CORRECTION(S) TO WATER WELL RECORD (WWC-5)

(Well # ELY 15-02)

Re: Corrected water Well Location
Monitoring wells KCC
McPherson County

RUNNING TURKEY CREEK
ERRORS IN THE FINAL REPORT BY T & C MFG OPER.

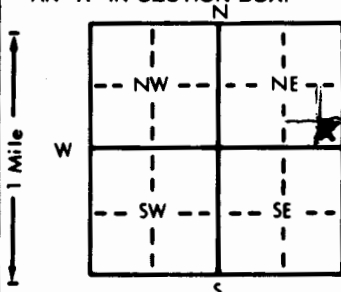
Location listed as:

Section-Township-Range: 4-21 S-3 W

Fraction ($\frac{1}{4}$ $\frac{1}{4}$ $\frac{1}{4}$): SW SE NE

Location changed to:

9-21 S-3 W

E2 E2 SE

Comments: Latitude: 38.23593° N., Longitude: 97.6476° W.

14. MW 14-02 OK
- ✓ 15. MW 15-02 Wrong spot location and section. WWC5 form also reflects the wrong spot location and section. Wrong Lat./Long?
- ✓ 16. MW 16-02 Wrong spot location and section. WWC5 form also reflects the wrong spot location and section. Wrong Lat./Long?
